### From Leo Bellantoni

### From Steve Chappa:

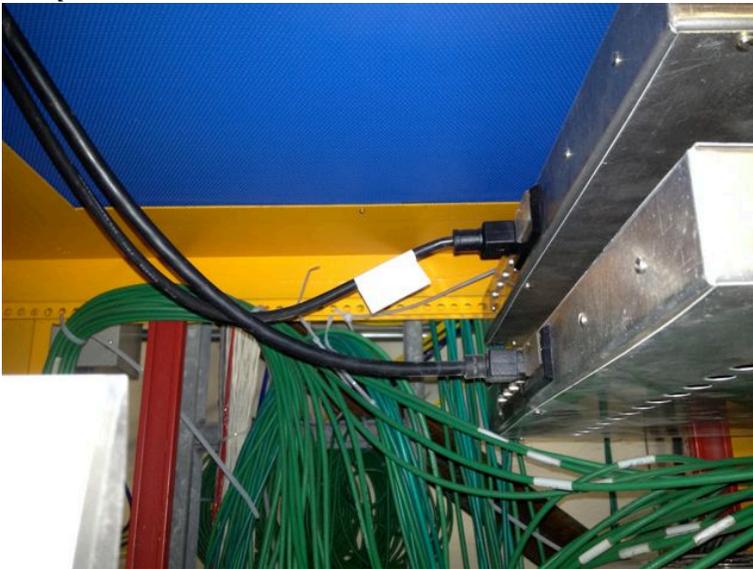
1) The PEM mounting screws are checked so that they are secure (since they provide the safety ground connection to chassis).

*The PEM mounting screws are checked at PC4 and they are secure.*

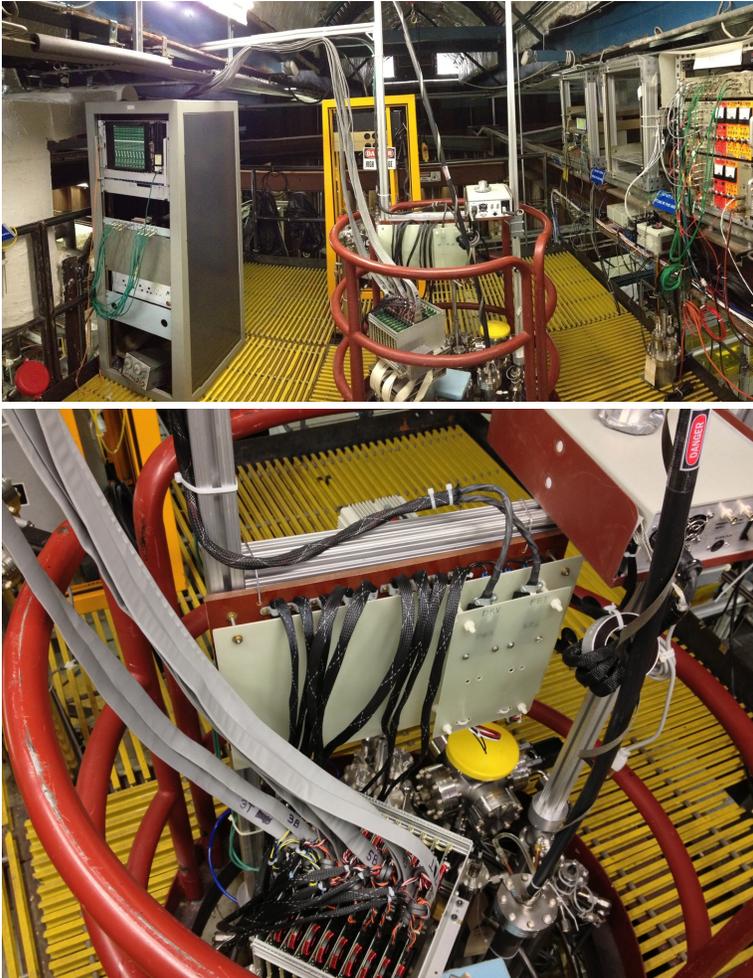
The TPC electronics rack located on the catwalk at the top of the vessel needs to have rack protection provided of the type that includes (at a minimum) a smoke detector wired to turn off power to the rack in case of an alarm.

*Rack protection is installed and tested to be functional.*
